: 206/OH-58 SADDLE, INBOARD, LEFT SIDE - UNDER

### **Process Sheet**

DART AEROSPACE LTD	Work Order:	30482
Description: 206 Saddle, Inboard, Left side	Part Number:	D2939-1
Inspection Dwg: D2939 Rev. B		Page 1 of 1

DART AEROSPACE LTD	Work Order:	30482	
Description: 206 Saddle, Inboard, Left side	Part Number:	D2939-1	
Inspection Dwg: D2939 Rev. B		Page 1 of 1

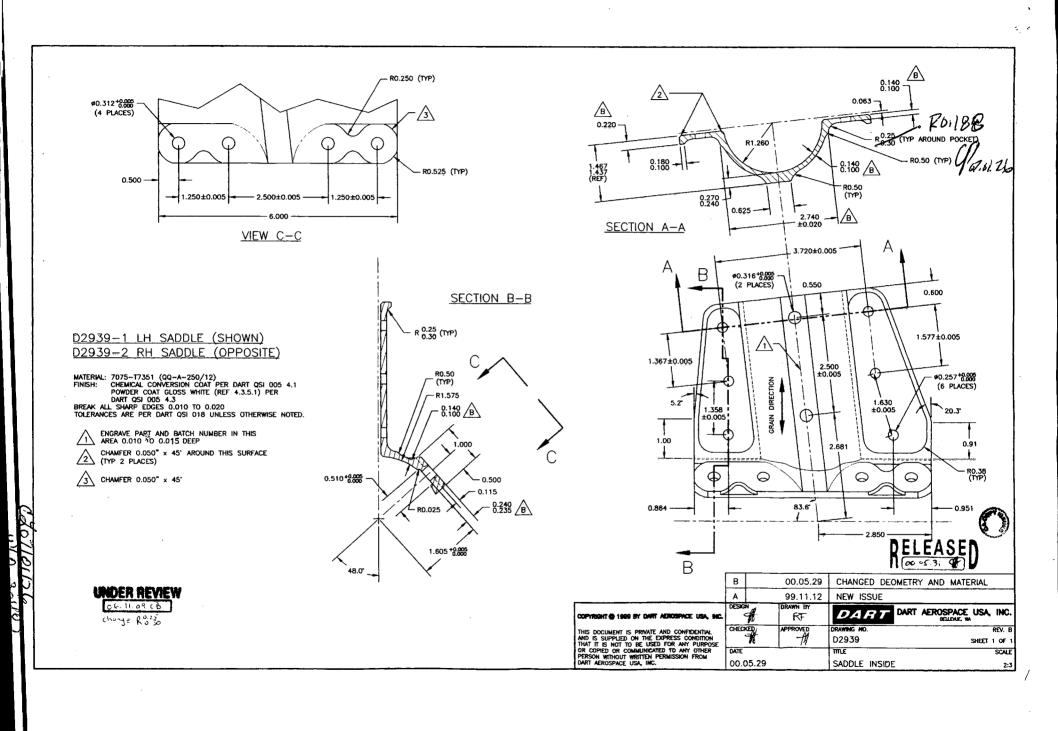
W/O:		WORK ORDER CHANGES								
DATE	STEP	P PROCEDURE CHANGE By C				Approval Chief Eng / Prod Mer	Approval QC Inspector			
67.01.26	2	TOOL RAD FOR FLANGE POLKETS SHOULD BE ROMBS				07.61.26 Des 64.26

NCR:	, ₹	W	ORK OR	DER NON-CONFORMANCE	E (NCR)			
DATE	OTER	Description of NC		Corrective Action Section B		Verification	Approval	Approval
DATE	STEP	Section A	Chief Eng Chief Eng		Sign & Date	Section C	Chief Eng	QC Inspector
Offoiles	1	flange of saddle is .094. should be between .140.100 .006. under hol.	PS ONLE OF INITIAL	Plant acceptable. Ipanlarly. advistoffset.	50	070129	Mar and a shorter	0701.25
,

On attach saddle drawing, according to Eric the marked-up radius that reads 0.30 and 0.25, should be 0.188 since the tooling has been changed long time ago, and apparently they have been machining those radiuses to 0.188 for a while. Do you see a problem with that? if not I will go ahead and change the drawing to reflect the changes.

Change the drawings. I guess we will also change the 0.313 crosstube hole dimensions as well. See D2661 to D2668 as well as D2932 to D2933.
